Service Update

49870 Splash Guard Damage

Reference Number: N162049870
GWM Number: 2049870

Release Date: June 2016
Revision: 00

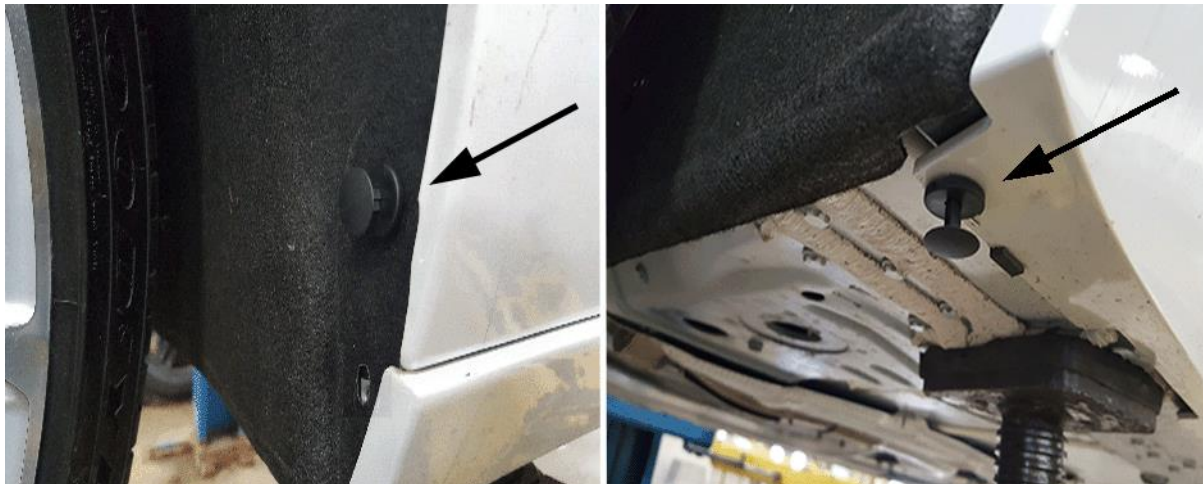
Condition	Certain 2016 model year Cadillac CT6 vehicles may have a condition where ground contact of the splash guards may result in breakage, severe wear of the splash guards, and potentially buckle the fender's inner flange.
Correction	Dealers will un-install the front and rear splash guards, and plug the drilled holes with push pins.

2. Remove the front splash shield screws (1) and drill out rivet (2).

Note: If the finish is damaged from drilling out the rivet, use touch up paint to prevent any corrosion issues.

3. Discard the screws removed from the front splash shield.

4. Install 2 push pin retainers in the location shown above (1).
